# UNITED STATES PATENT AND TRADEMARK OFFICE

APPLICATION NO.	FILING DATE	FIRST NAMED INVENTOR	ATTORNEY DOCKET NO.	CONFIRMATION NO.
10/528,986	03/24/2005	Robert Simm	3210	6382
<div>7590 Striker Striker &amp; Stenby 103 East Neck Road Huntington, NY 11743</div>				
			EXAMINER CADUGAN, ERICA E	
			ART UNIT 3722	PAPER NUMBER
			MAIL DATE 07/20/2007	DELIVERY MODE PAPER

**Office Action Summary**

### **DETAILED ACTION**

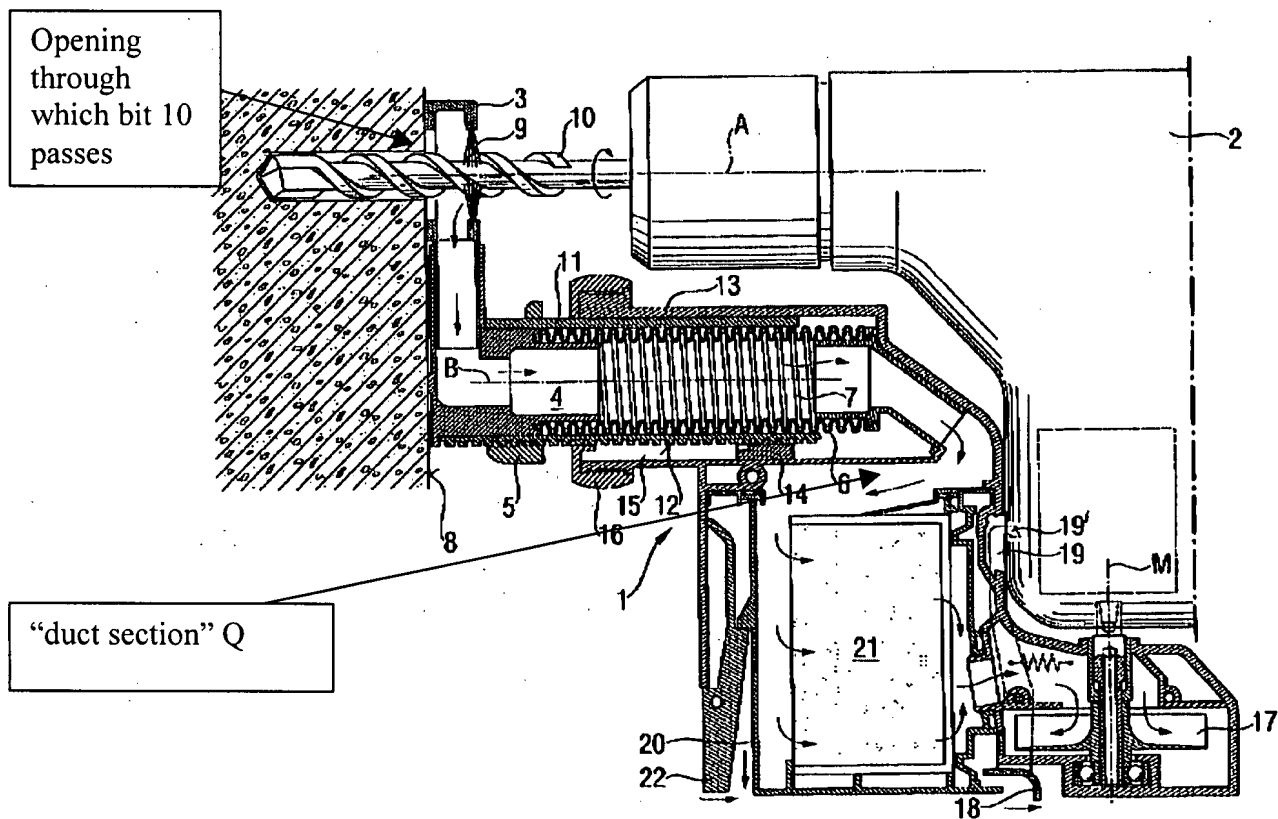
Ege et al. discloses a suction device for a power drilling tool 2 with at least one “dust container 20” and at least one “suction head” 1 to be placed on a work piece 8 (at portion 3 of the “suction head” 1), wherein the dust container 20 is “integrated in”, i.e., forms a part of or is incorporated in, the “suction head” 1 (see Fig. 1).

Re claims 2-3, a suction unit including the “cooling fan” 17 and the motor M is “integrated in” the power tool for producing a vacuum in the suction head (see Fig. 1).

Re the “bearing unit” of claim 1 and also re claim 6, note that the “suction head” 1 is supported on the housing of the power tool 2, and is detachably retained thereon via a snap-in connection 19, 19'. Re the claimed “unit” and “bearing unit” of claim 4, as broadly claimed, it is noted that a “unit” including a “bearing unit” including at least elements 13, 11, and 5 “support” the “suction head” 1 on the housing of the power tool 1 (insofar as the guide rods 46a and 48a forming the disclosed bearing unit of the present invention serve to support the suction head on the power tool housing).

Re claim 1, it is noted that the “suction head” 1 is supported on the housing of the power tool 2 by the “bearing unit” including at least elements 13, 11, and 5 as described previously. It is further noted that the suction head 1, including the integrated dust container 20, is indeed, as broadly claimed, “displaceable along a working direction” (such as the left right direction of the A axis of Figure 1) by, at the very least, moving the entire device (i.e., the power tool 2 in combination with the suction head 1) in the left-right direction as viewed in Figure 1, at the very least to move the device into a position adjacent the workpiece.

Re claim 8, note that the aforescribed “bearing unit” including at least elements 13, 11, and 5 includes the depth stop 5 (see Figure 1 and paragraph 0024).

Re claim 9, note that the suction head 1 includes an opening (labeled below in the reproduction of Figure 1) through which the tool bit 10 is guided during a drilling operation of the workpiece (workpiece is at the left side of the Figure and has a surface 8).

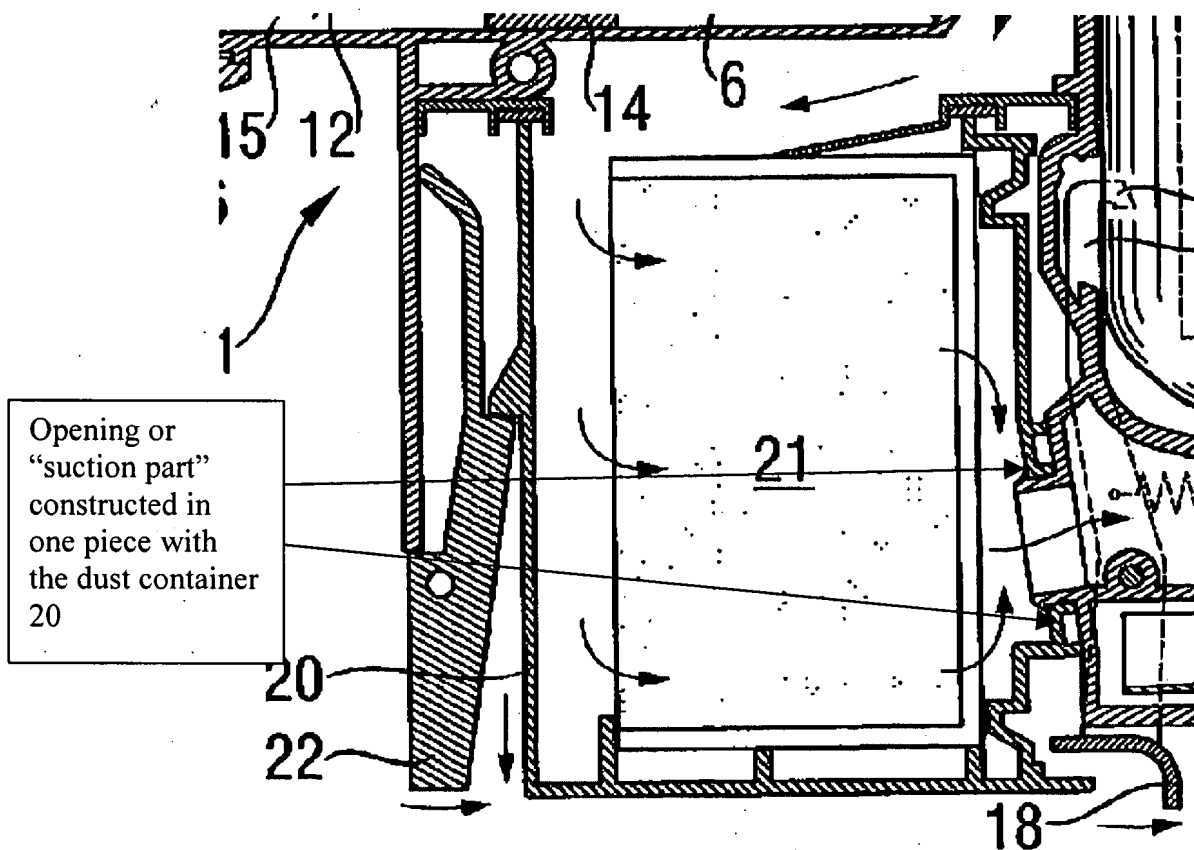
Re claim 12, an air stream (at least as defined by the arrows in Figure 1) is "capable" of being introduced into the dust container 20 through a "duct section" (including at least any one of the hollow portions 3 or the tube 4, or the above-labeled "duct section Q", for example) in a circumferential direction of the dust container (see Figure 1).

Re claims 14-15, it is noted that the "suction part" 34a-34c of the present invention is not any sort of vacuum, but is merely a part through which suction occurs. That being said, it is noted that the above-labeled "duct section Q" is a part through which suction occurs, and which

is thus considered to be a "suction part", and which "forms a single unit" (claim 14) that "forms a one-piece unit" (see Figure 1 noting that at least the left side of the duct section Q is of the same piece as the container 20 (see Figure 1). [Alternately, note that the opening through which air passes as it leaves (on the right side) of the dust container is a part through which suction occurs, which could thus alternatively be considered the claimed "suction part", and which is a single unit that forms a "one-piece unit" with the "dust container" 20].

Re claim 16, considering the alternate interpretation of the "suction part" set forth in the immediately preceding sentence, see the enlarged and labeled portion of Figure 1 below.
